Guangzhou Zaozhongwan E-Commerce Co., Ltd.

Request of Class II Permissive Change

FCC ID: 2BDKK-KM-LAV02-BAT

Comparison Photos:

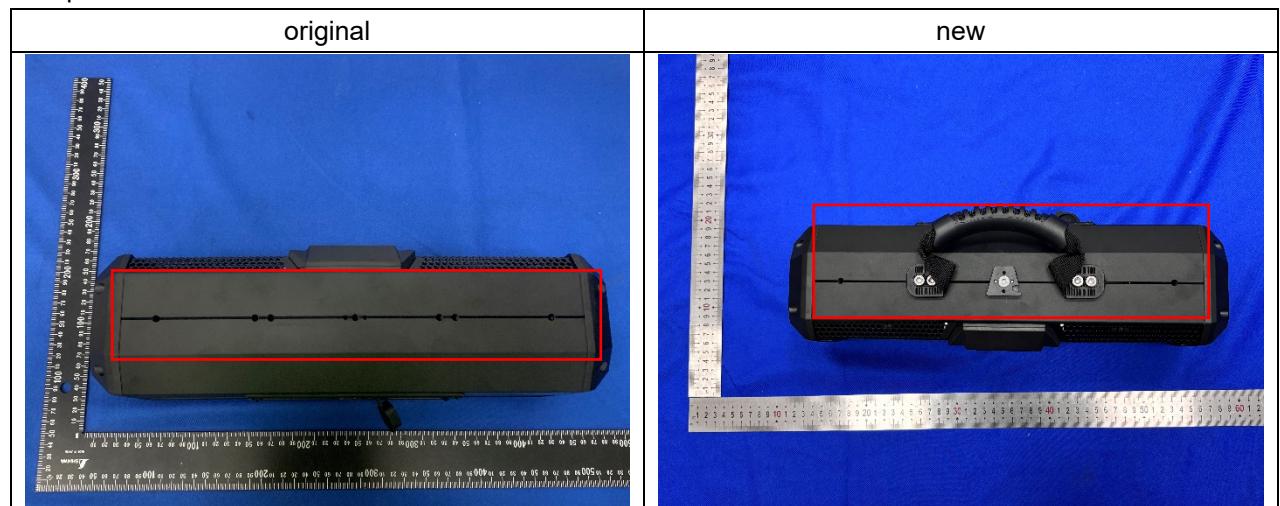
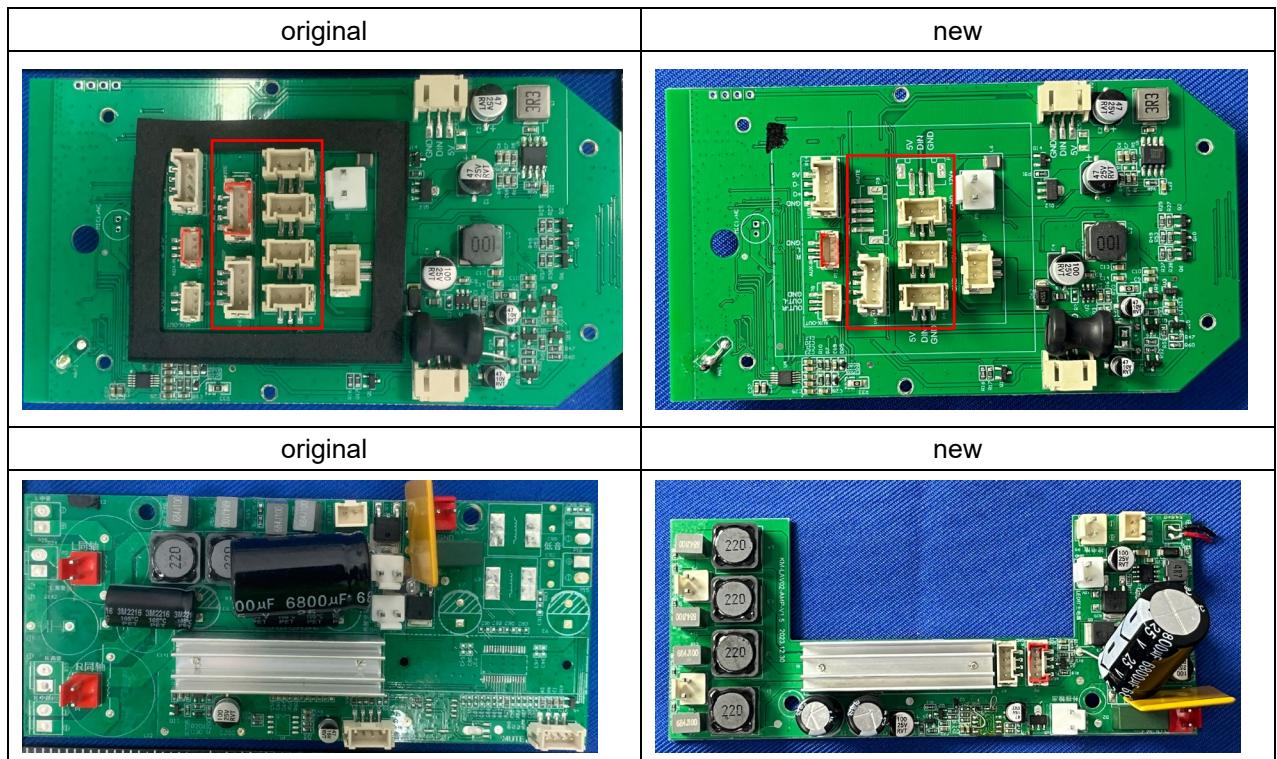
- (1) Changed the charging circuit and battery;
- (2) Changed the model no. to "KM-Midnight40B";
- (3) Changed the product appearances (add a carrying handle to the top);
- (4) Removed the light strip connector and the mute signal cable connector.

All others are the same in electrical parameters and internal circuit structure. Therefore, re-tested radiated emissions and pre-tested the conducted output power, the test results are less than or equal to the original value, so the test data was refer to the original reports.
